**Addendum No.: 1**

**Quote#: 26-17-1**

**Project Name: Tammany Trace Solar Pedestrian Activation System**

#### 1. Intersection Map

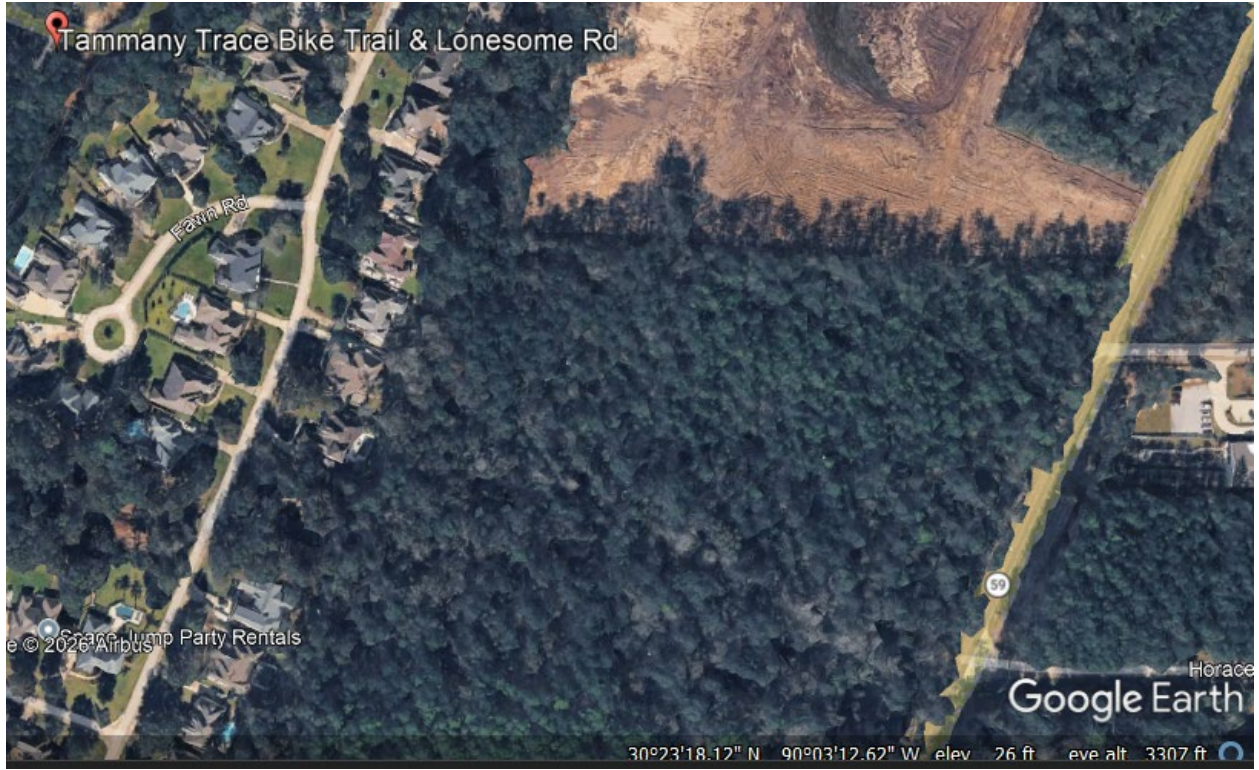
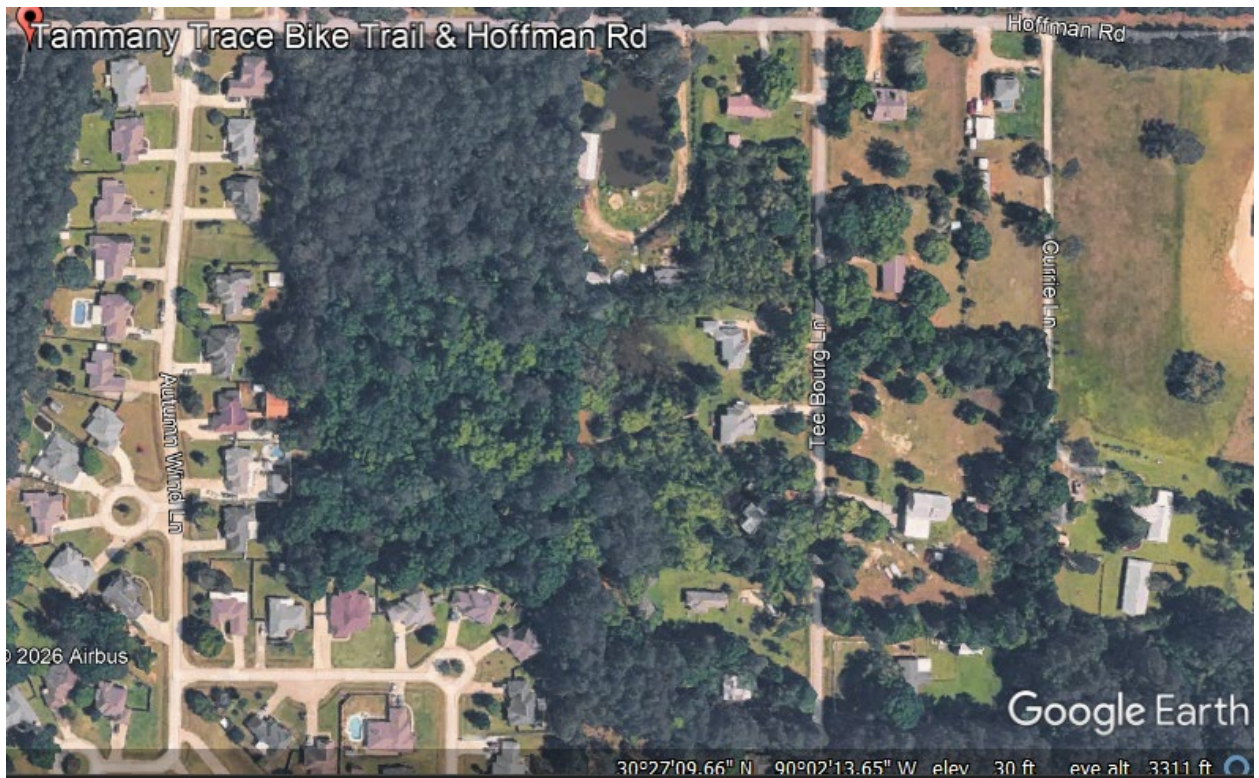
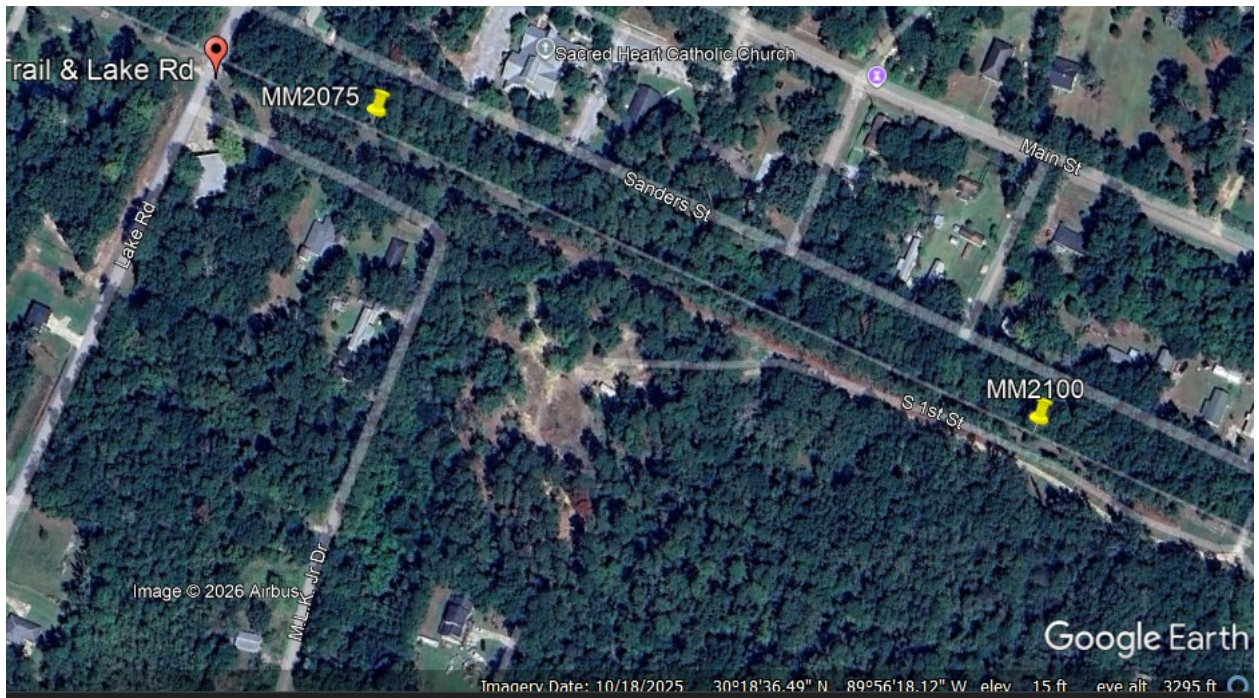
Question 1. While street names have been provided, no cross streets or exact coordinates are included. This information is necessary to ensure all bidders are reviewing the same site conditions and can provide consistent and accurate pricing.

**Answer 1. An Intersection Map has been provided.**
